Proposal #27: 9240-08-70, WISC 2016 418
Park Falls - Springstead
N Fork Flambeau Rvr Bridge B-50-0082
STH 182
Price County

9240-08-71, WISC 2016 419
Park Falls-Springstead
STH 13 - Sanders Avenue
STH 182
Price County

Letting of November 8, 2016

This is Addendum No. 01, which provides for the following:

Addendum No. 01
ID 9240-08-70/71
Revised Sheet 2
November 2, 2016

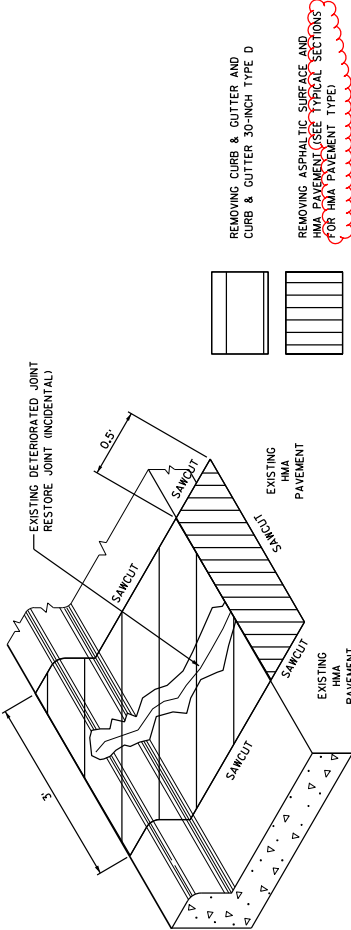
Revised Plan Sheets	
Plan Sheet	Plan Sheet Title (brief description of changes to sheet)
2	General Notes (third general note: removed reference to 4 LT 58-28 S pavement type)
4	Typical Sections (center left and bottom sections: changed HMA pavement type from 4 LT 58-28 S to 4 MT 58-28 H, center right section: changed HMA pavement type from 6" HMA Pavement 4 LT 58-28 S to 2" HMA Pavement 4 MT 58-28 H/4" HMA Pavement 4 MT 58-28 S)
5	Construction Details (top left and bottom left details: removed reference to 4 LT 58-28 S pavement type)
34	Miscellaneous Quantities (Asphaltic Pavement Items: removed item 460.5224 and added items 460.6224 and 460.6424)

THE 6" HMA PAVEMENT SECTION SHALL BE PLACED IN 3 2-INCH LIFTS.
